SOLACE AT CIMARRON HILLS
- FILING NO. 1
SITE AND OVERALL UTILITY
PLAN
SHEET 4 OF 32
JOB NO. 25174.00

SITUATED IN THE NORTHWEST QUARTER OF SECTION 7
TOWNSHIP 14 SOUTH, RANG 65 WEST OF THE SIXTH PRINCIPAL MERIDIAN
COUNTY OF EL PASO, STATE OF COLORADO
WATER DISTRIBUTION PLAN

SOLACE AT CIMARRON HILLS
COVER SHEET
WATER DISTRIBUTION PLAN
SHEET 1 OF 10
JOB NO. 25174.00

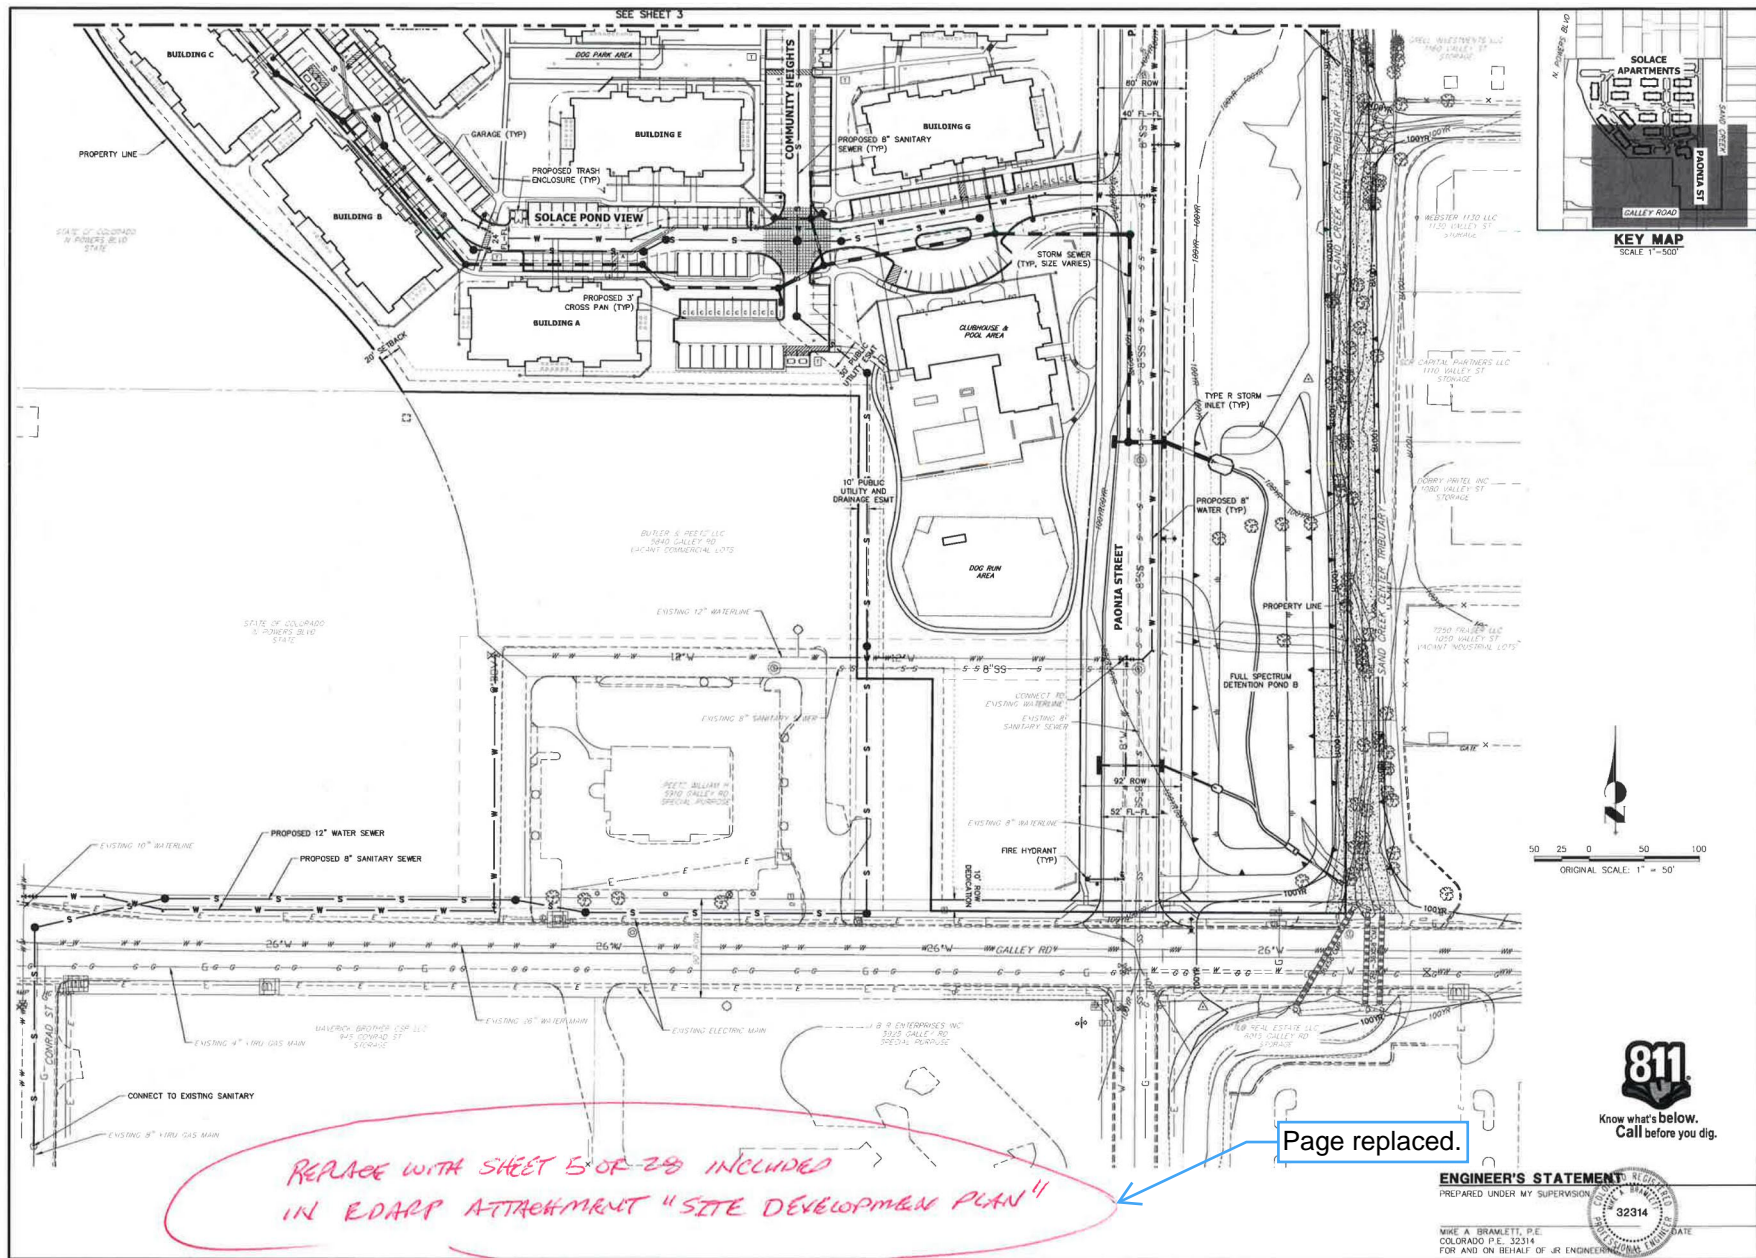
REPLACE WITH SHEET 5 OF 28 INCLUDED
IN EDARP ATTACHMENT "SITE DEVELOPMENT PLAN"

Page replaced.

SHEET 1		JOB NO. 25174-0		1"=2000'		NO. REVISION		BY DATE	
COVER SHEET		DATE 3/12/21		V-SCALE N/A					
DESIGNED BY APL		DRAWN BY APL							
SANITARY SEWER PLAN AND PROFILE

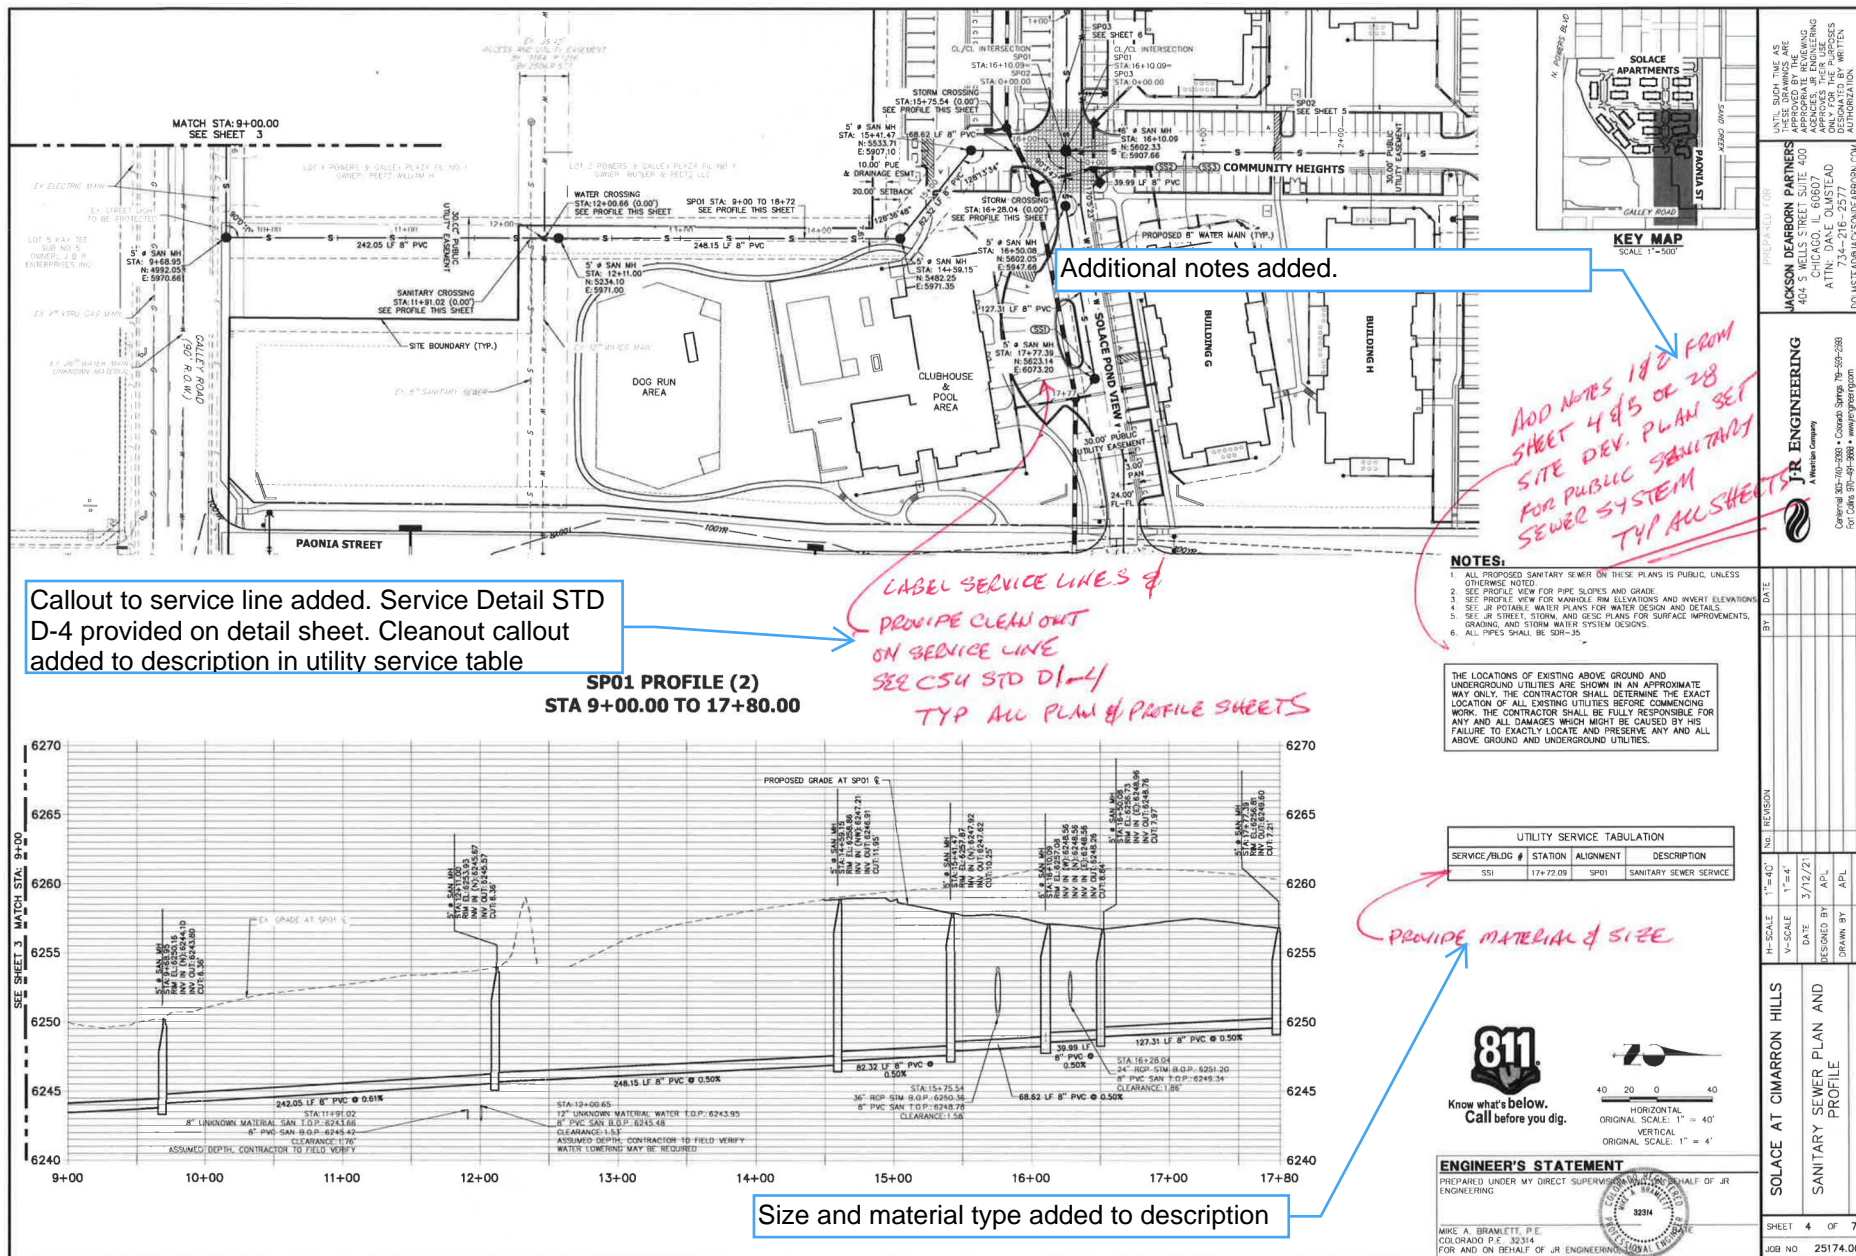
REPLACE WITH
SIGNED SHEET

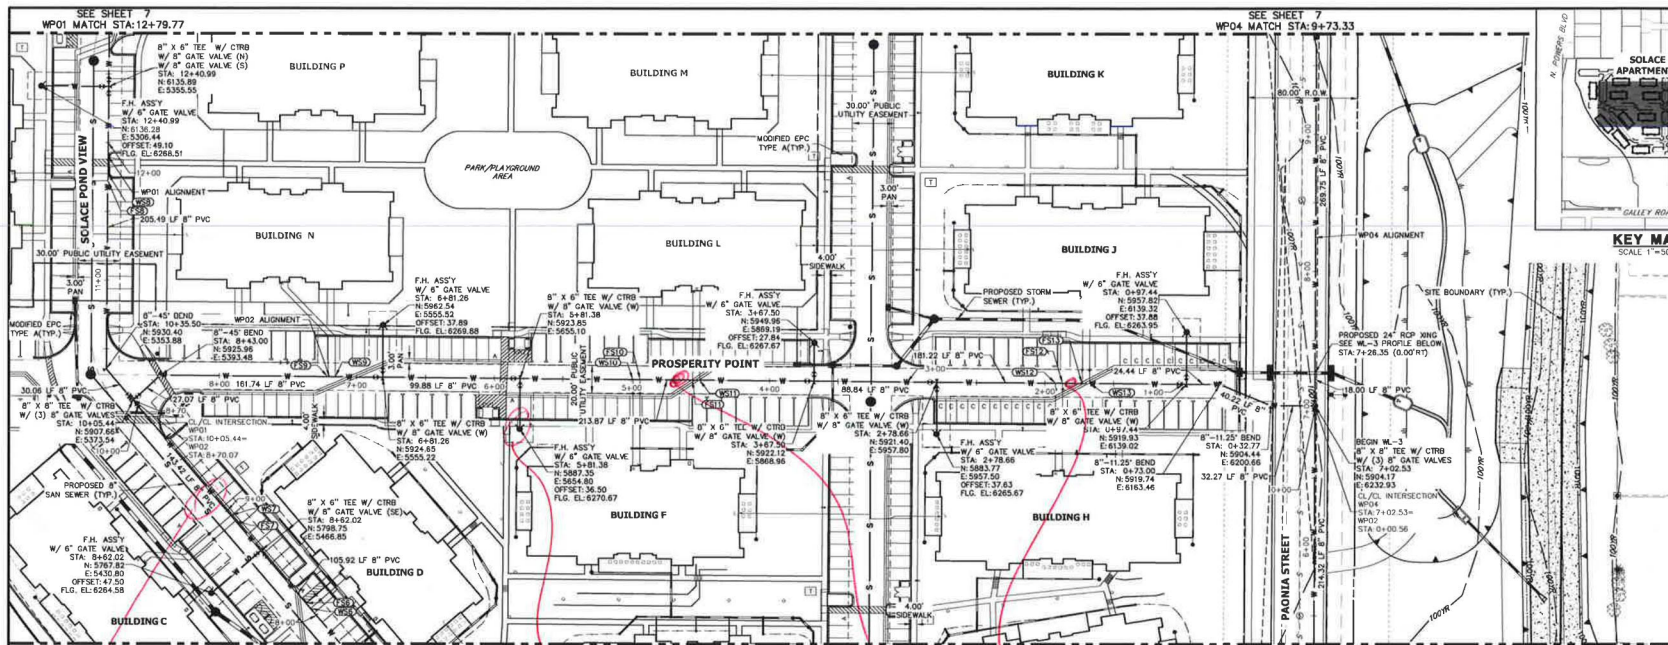
ADD SIZE & MATERIAL OR USE GENERAL NOTE

CONFIRM W/FIRE DEPT THAT HYDRANT CAN BE BEHIND PARKING STRIP (TYP)
WL-3 PROFILE
STA 6+70.00 TO 8+00.00

SHOW VALVES ADDED TO MATCH SHEET 4 OF 28 "SITE DEV. PLAN"

CANCEL 30' PUBLIC UTILITY EASEMENT
"NO COVERED PARKING FOUNDATIONS ALLOWED IN EASEMENT"

Pipe size & material added to table

Easement label added.

Fire department has approved of layout with hydrants located behind parking

Easement added.

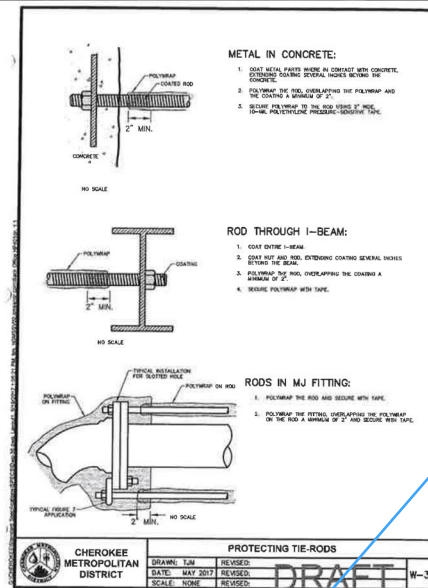
REPLACE w/ CSU

References revised to reflect CS standards
